Ansul has released Bulletin 5165a dated September 30, 2008 announcing ANSUL R102 UL 300 Fire Protection for Henny Penny mono rail center lift and dual lift fryers that automatically lift out the fried product. The UL 300 fire suppression protection offers protection in both the fully open and intermediate positions.

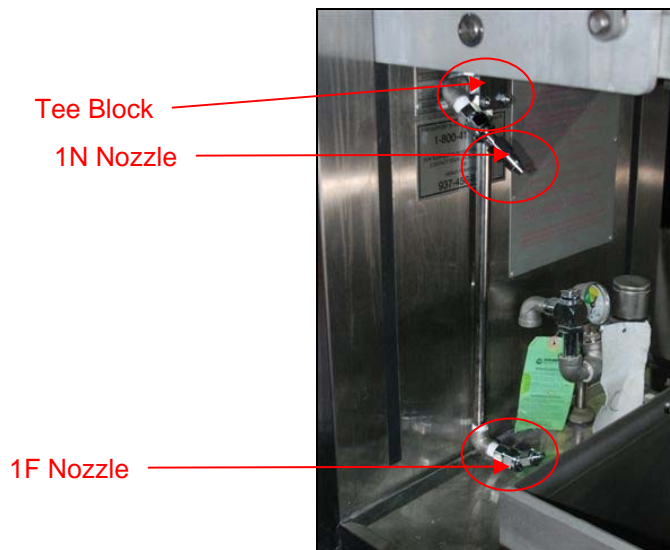
These fryers were previously protected using “Ansul Recommended” protection which only provided protection with the lid of the fryer in the fully open position. Non-UL 300 fire protection can be identified by the over head nozzle placement with the nozzles aiming into the vat area.

The UL 300 Fire Protection can be identified by the method of the nozzle placement. The UL 300 fire protection uses two nozzles and is directly mounted on the fryer utilizing a “tee block” as shown in the picture below.
